ADDENDUM

December 15, 2017

RFB NO. 317028 - ADDENDUM NO. 1

SCHUMACHER BARN REMODEL/SITE IMPROVEMENTS (REBID)

23. Sheet A5.0 - RESTROOM PLANS AND KITCHENETTE ELEVATIONS - ARCHITECTURAL

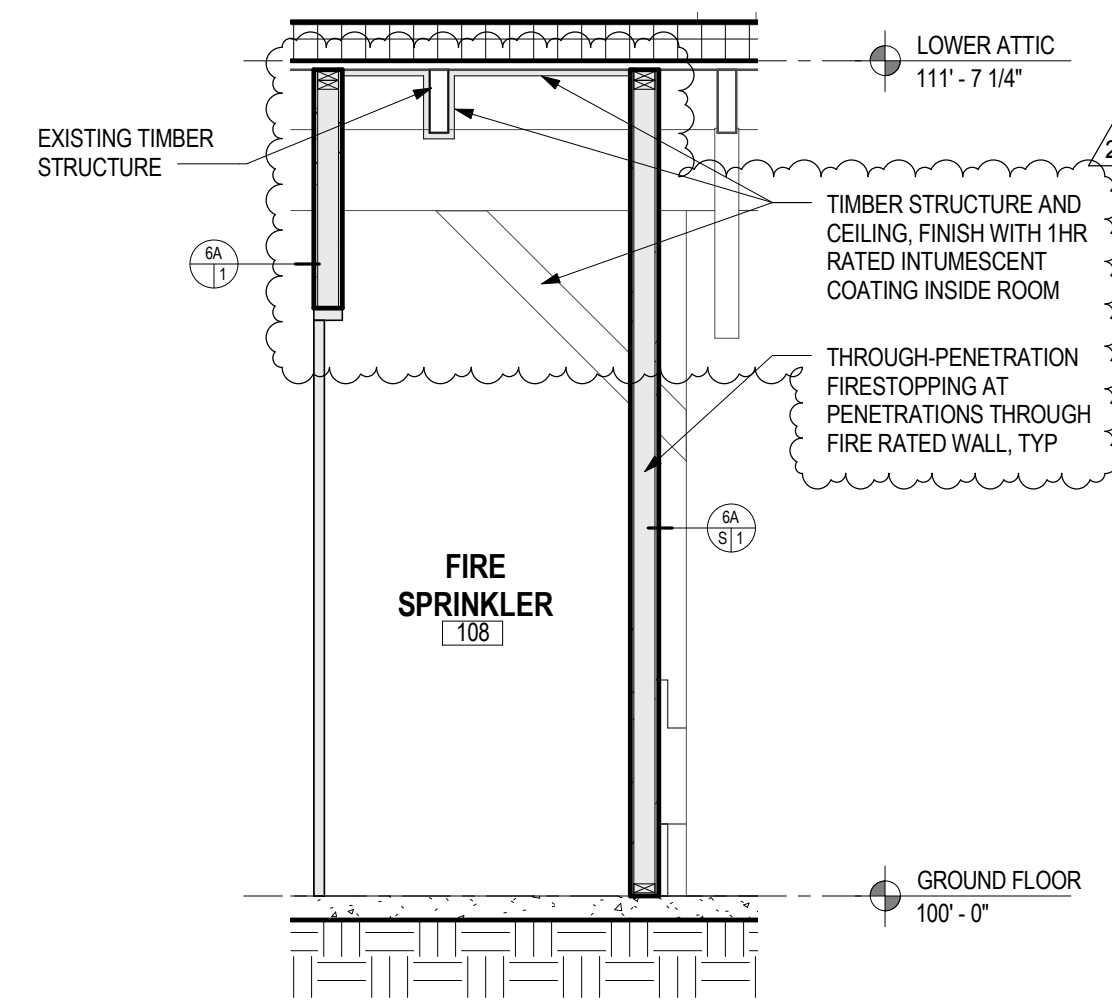
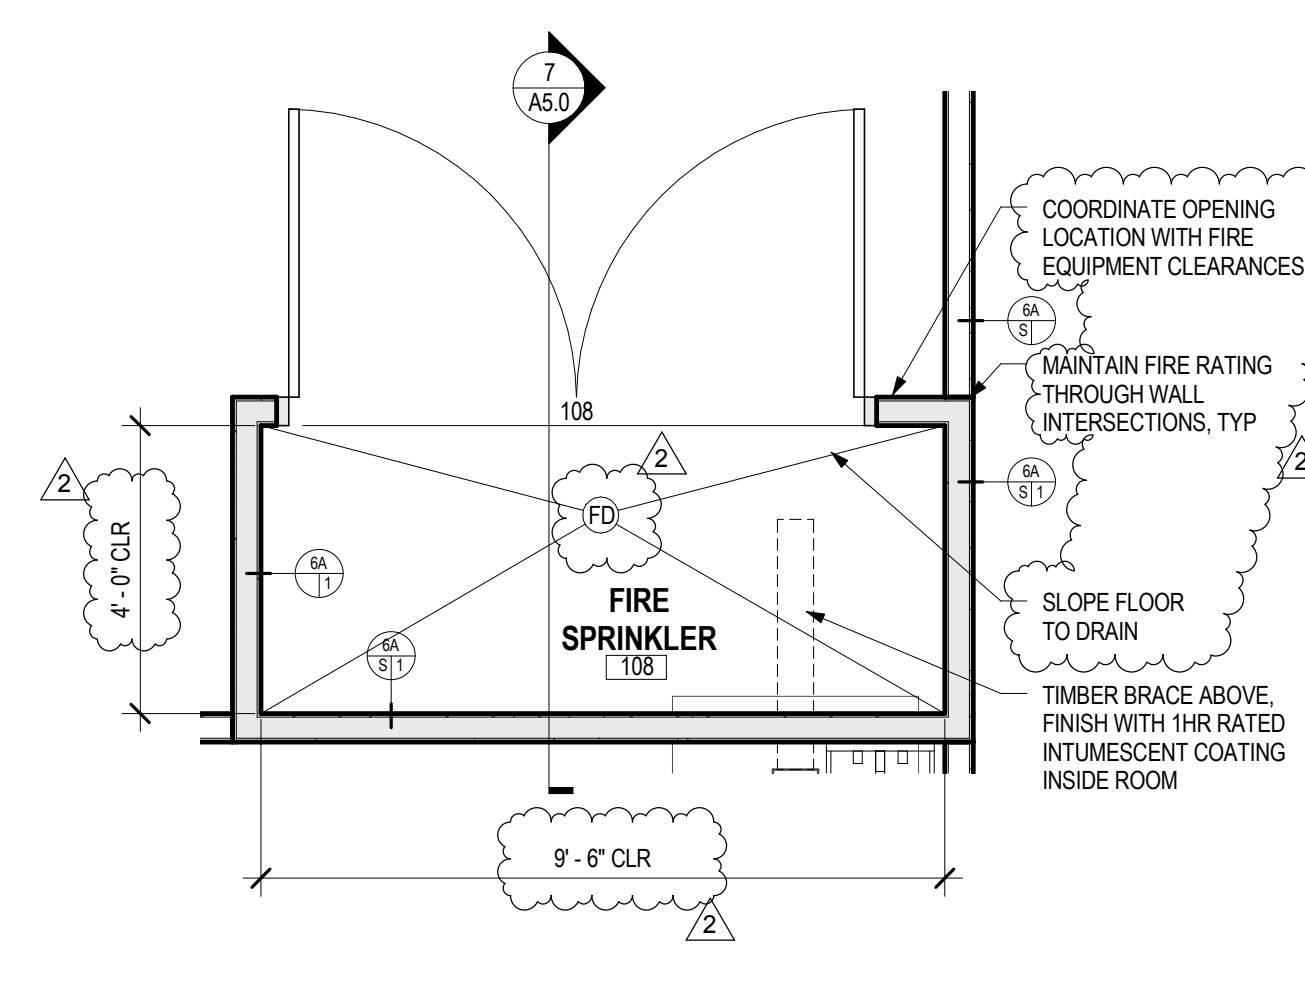
Delete current Sheet A5.0 and replace with new Sheet A5.0, issued with this Addendum
Revised detail 7-FIRE SPRINKLER ROOM SECTION
Revised detail 6-FIRE SPRINKLER ROOM PLAN

24. Sheet A6.0 - DOOR AND WALL TYPES AND SCHEDULES - ARCHITECTURAL

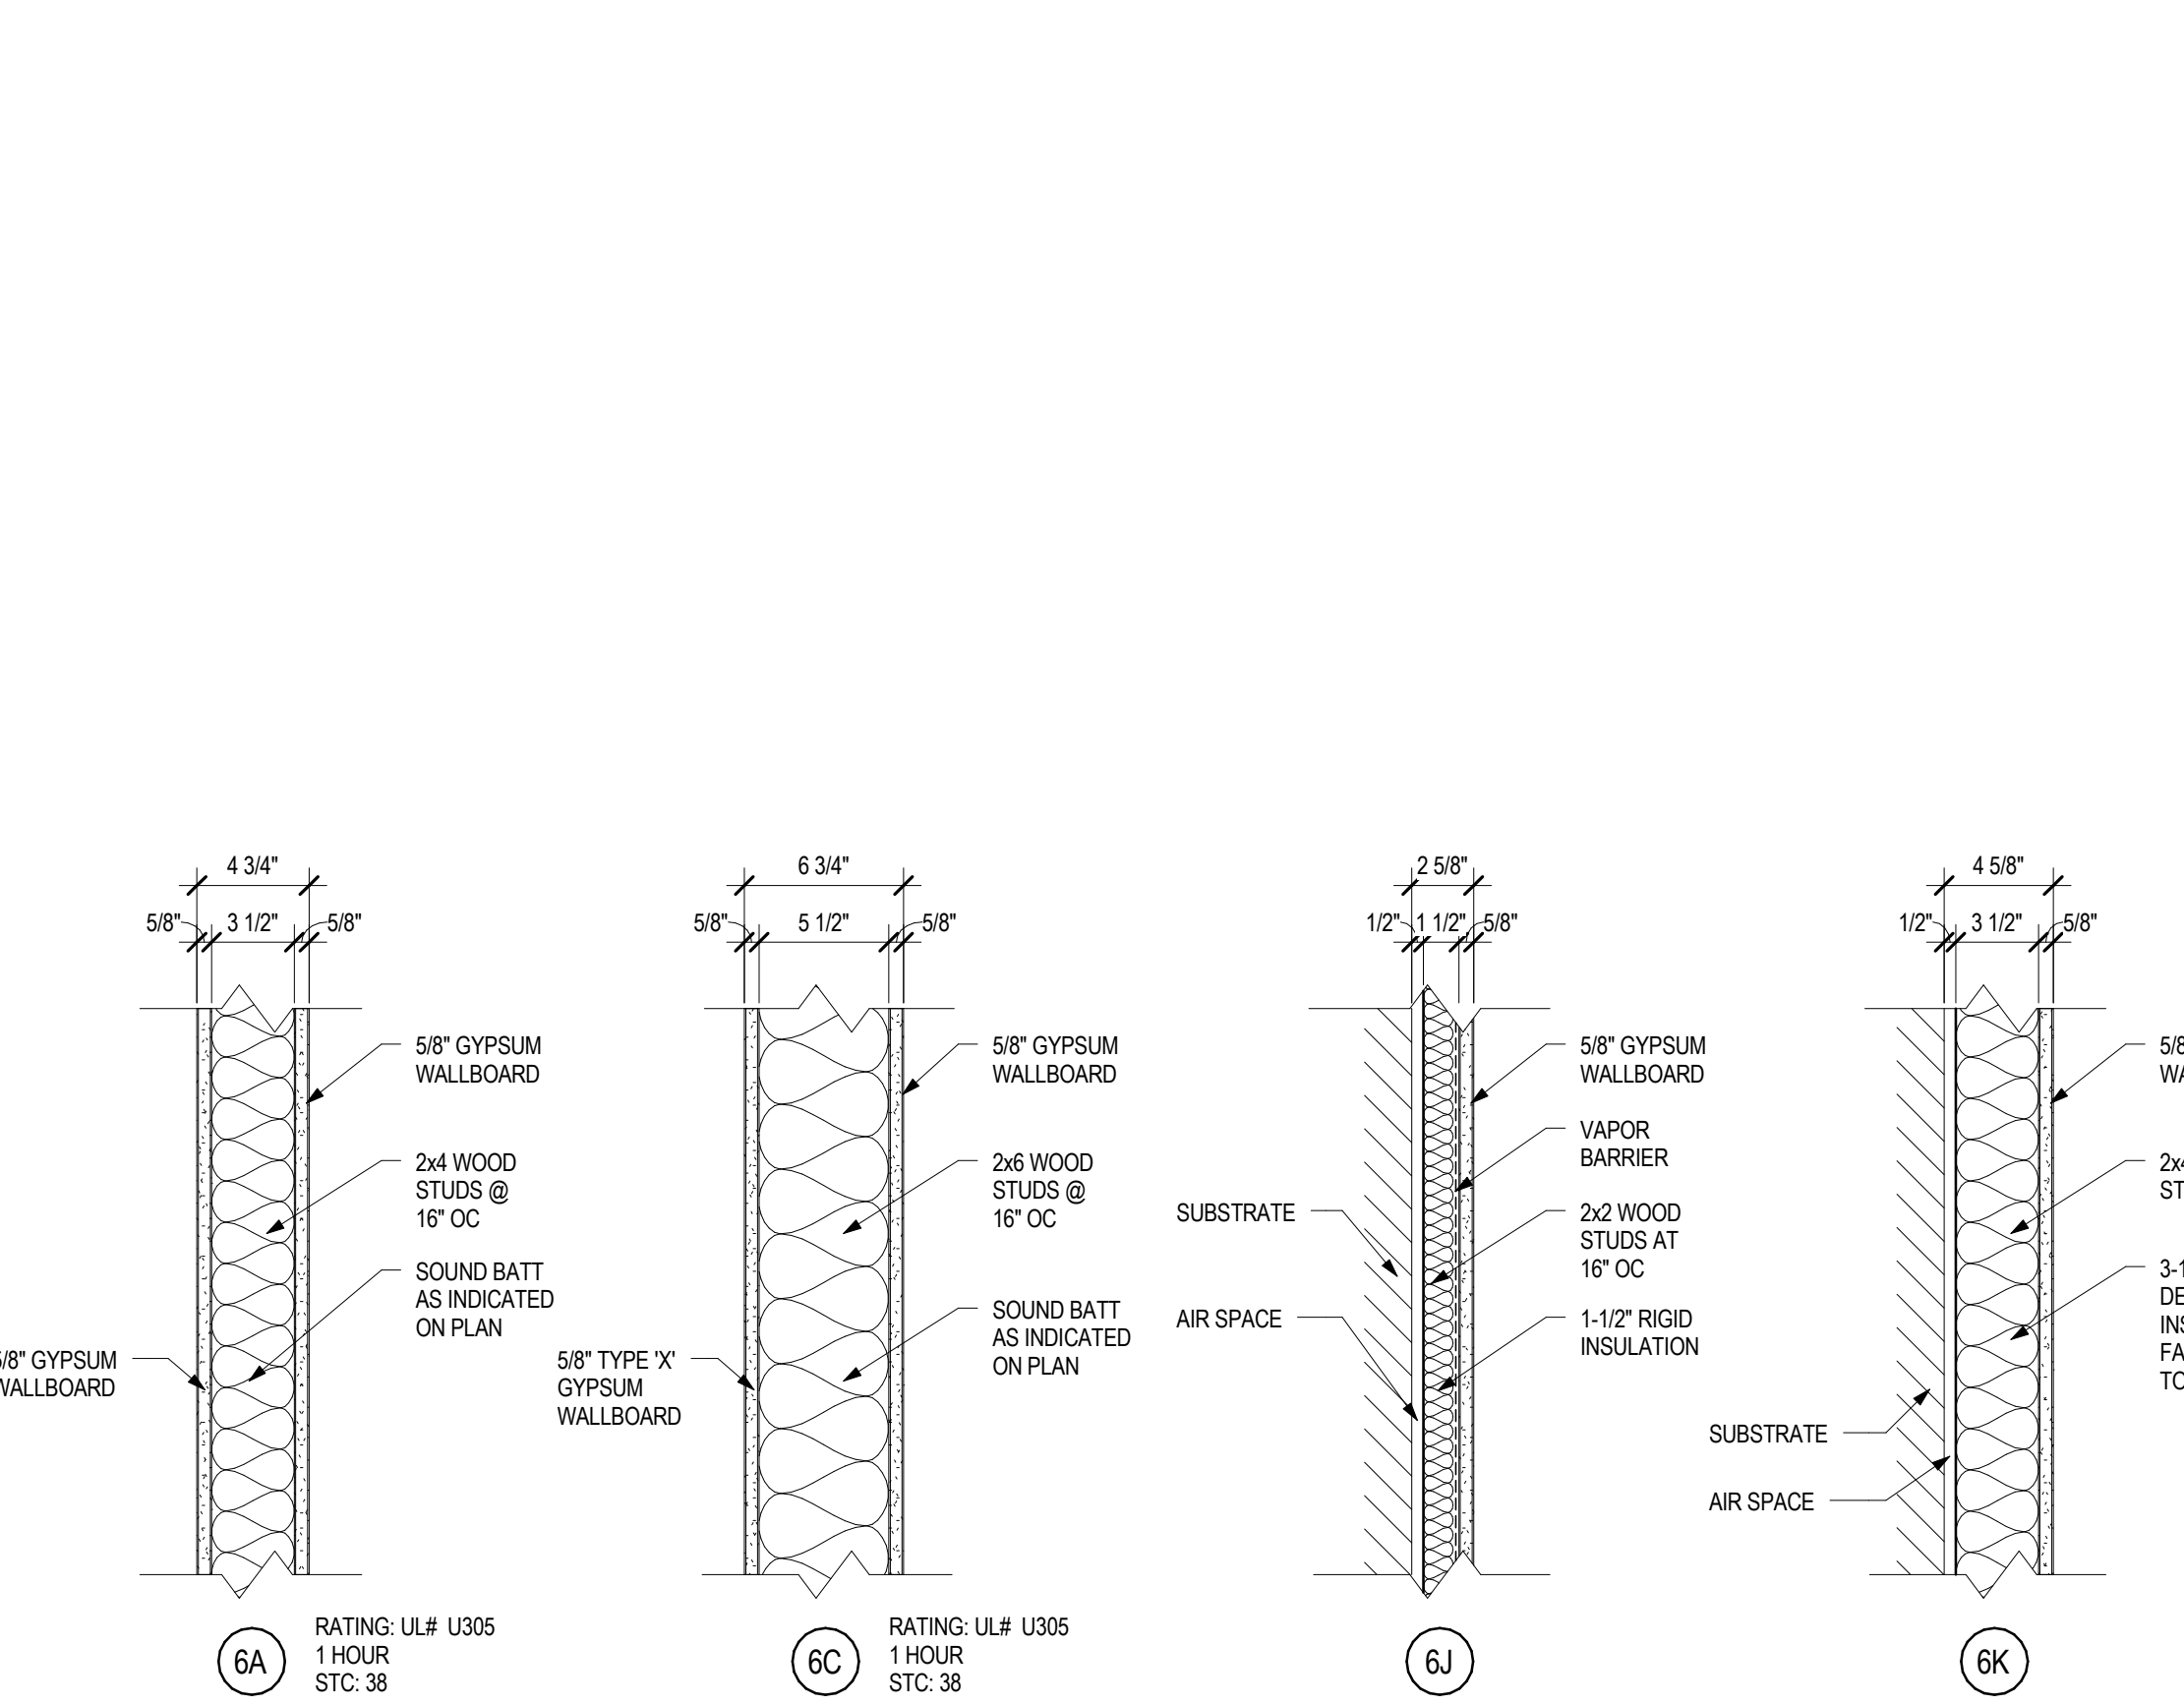
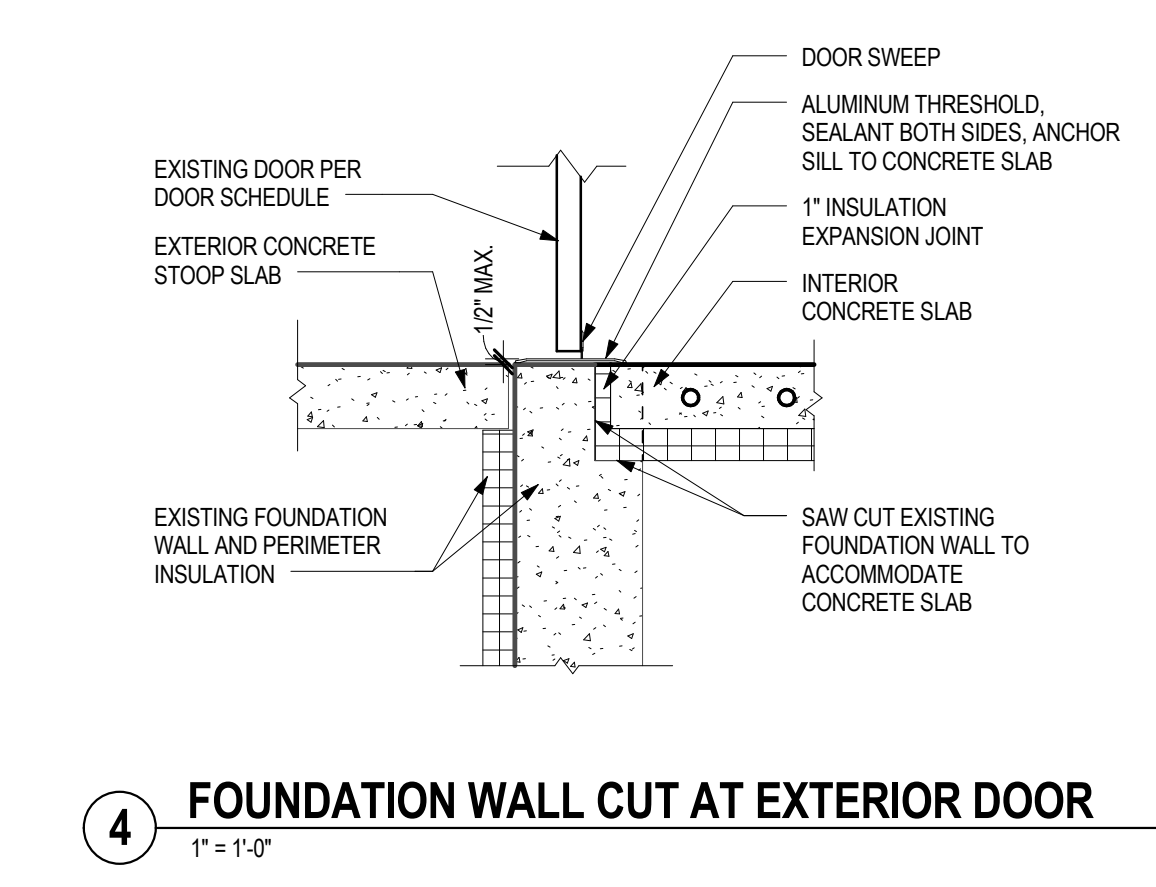
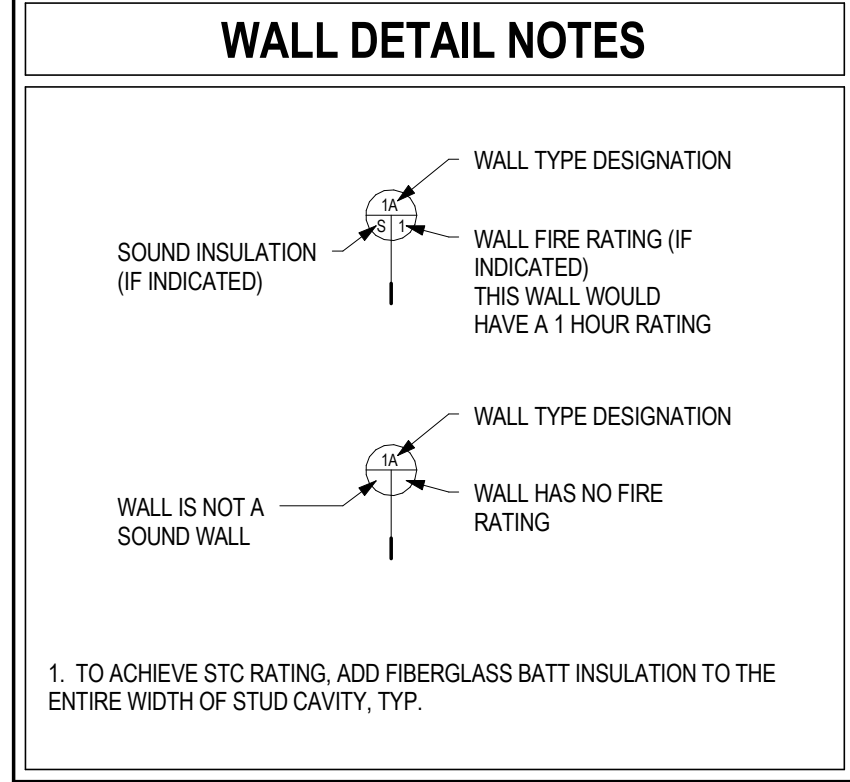
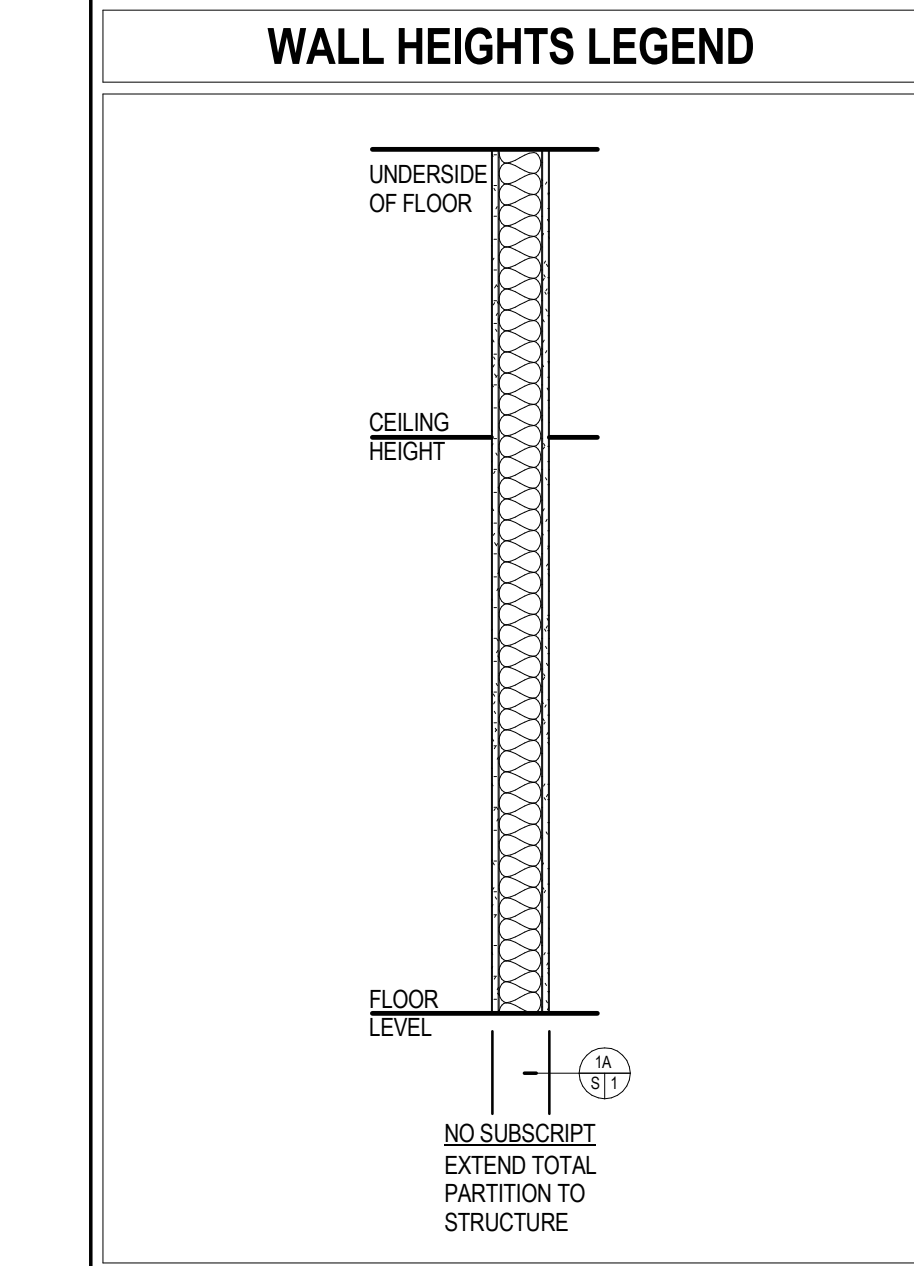
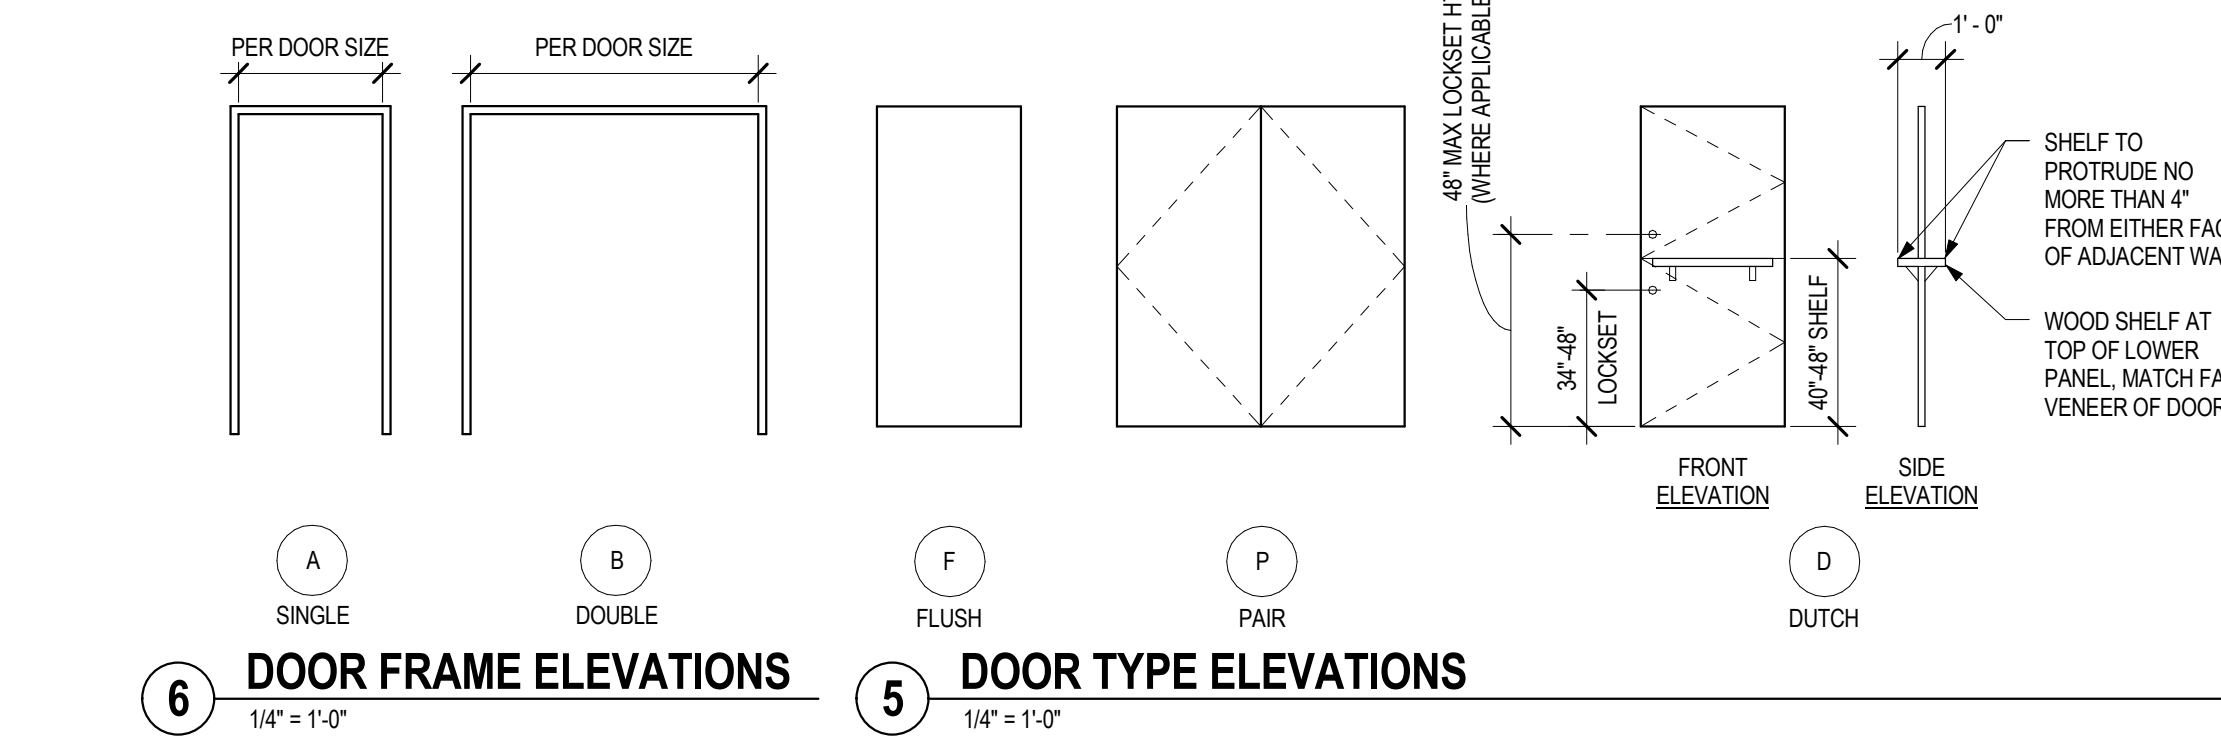
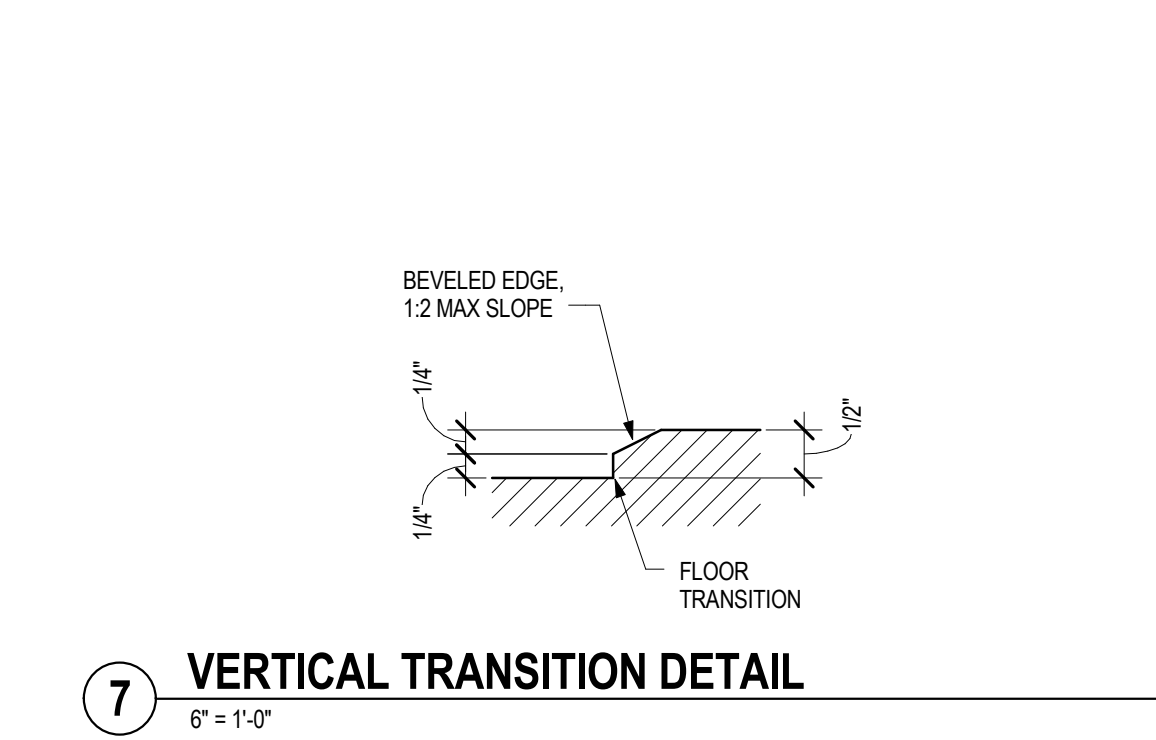
Delete current Sheet A6.0 and replace with new Sheet A6.0, issued with this Addendum
Revised door 108
